Louisville and Jefferson County Metropolitan Sewer District 700 West Liberty Street Louisville Kentucky 40203-1911 502-540-6000 www.msdlouky.org

Subject: Integrated Overflow Abatement Plan

Public Input Meeting, January 24, 2012

Response to comments

Map of: 2402 Gray Fox Rd Louisville, KY 40205-1612

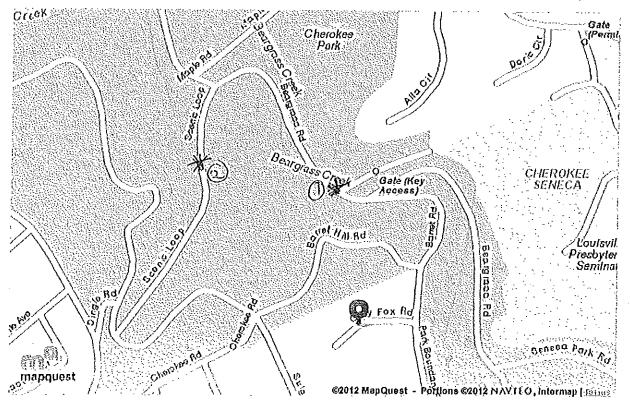
Comment 1 – At the location shown on the map, point 1, there is a major sewer overflow after ½-inch of rain. Sewage is present until the next rain, sometimes for a month. An overflow also occurs at point 2 on the map.

<u>Comment 2</u> – What is MSD doing to get rid of sewer overflows in Cherokee Park? The I-64 & Grinstead Basin?

# 1 Major sewage Overflow after 2" of rainfall, sewage is present until next rain, sometimes for a month!

#0 50 yards up from everk.

Response to Comment 1 – MSD is aware of the sewer overflows at the two locations identified on the map. The overflow indicated as "1" on the map is a MSD manhole #27005. The overflow indicated as "2" on the map is MSD manhole #40559. These locations are currently part of routes that are routinely inspected for overflows during wet weather. If an overflow is observed or evidence of a sewer overflow is confirmed following wet weather, MSD sends crews to check the area and perform clean up as appropriate. MSD reports the overflows to the Kentucky Division of Water and the Environmental Protection Agency. See Response to Comment 2 below for the solution defined for these overflows.

Response to Comment 2 – MSD has performed a televised inspection of the sewer lines in this area and is currently reviewing the inspection data and developing rehabilitation plans for the sewer line. The rehabilitation of this line will help reduce overflows. The green infrastructure projects that are currently being planned in this area will reduce overflows during small to moderate rain events. The elimination of these overflows will ultimately be

accomplished with the diversion of the Upper Middle Fork Pump Station (Breckenridge Lane) to a different interceptor sewer, which will be completed by 2024 as part of the Amended Consent Decree.
